Addendum No. 1

**CDBG-MIT GLO CONTRACT NO. 22-085-009-D237
(CITY OF KINGSVILLE BID NO. 26-04)**

CITY OF KINGSVILLE GLO SW PROJECT 7 (S. 6TH ST.) STORM WATER IMPROVEMENTS

DATE: 1/18/2023 10:51 AM, USER: JAM, PROJECT: 21107-01B, SHEET: C14, DRAWING: STORM WATER PLAN AND PROFILE, STA. 0+00 (B.O.P.) TO STA. 5+00, SCALE: HORIZ. 1"=40', VERT. 1"=7' (FULL SIZE SHEETS), SCALE: HORIZ. 1"=40', VERT. 1"=14' (HALF SIZE SHEETS)

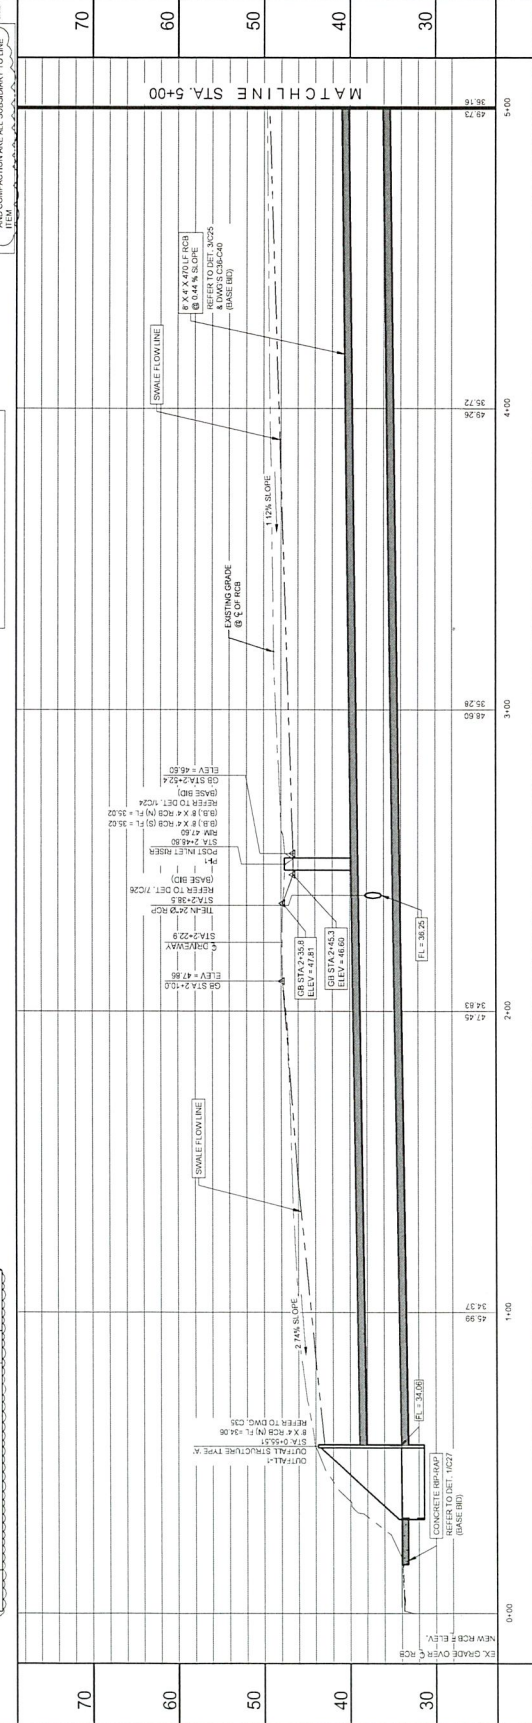
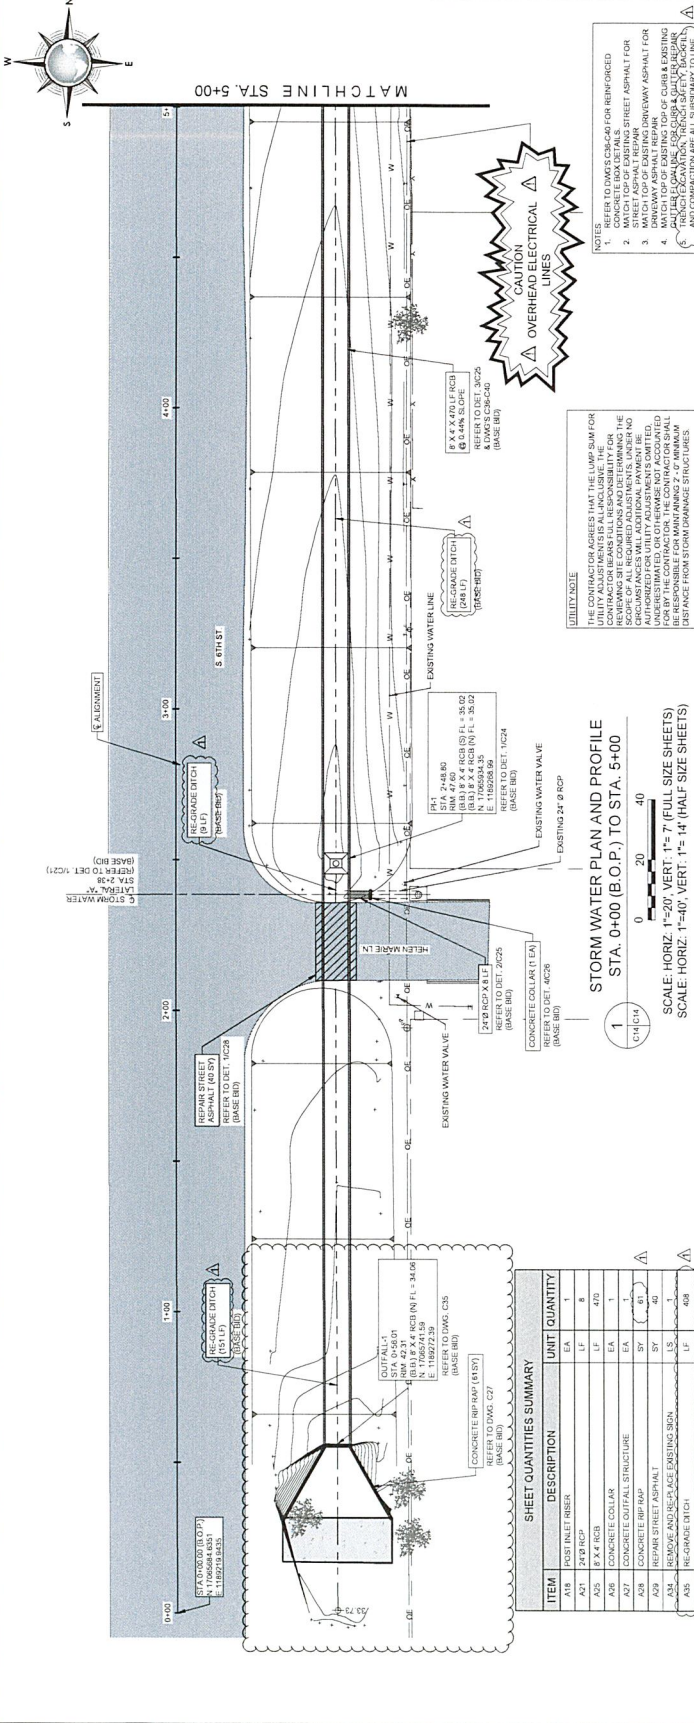
- III. Added a new item on the SHEET QUANTITIES SUMMARY TABLE “ A35 RE-GRADE DITCH”. Changed callout “SWALE FLOW LINE” to “RE-GRADE DITCH”. Revised NOTES by adding “5. TRENCH EXCAVATION, TRENCH SAFETY, BACKFILL, AND COMPACTION ARE ALL SUBSIDIARY TO LINE ITEM.”. Drawing No. C14 to C20.

- IV. Relocation of the OUTFALL structure and CONCRETE RIP RAP. Drawing No. C14.
- V. Added new sheets titled, “TXDOT- CONCRETE WINGWALLS WITH FLARED WINGS”, and “TXDOT – EXTENDED CURB DETAILS”. Drawing No. 35 and C58.
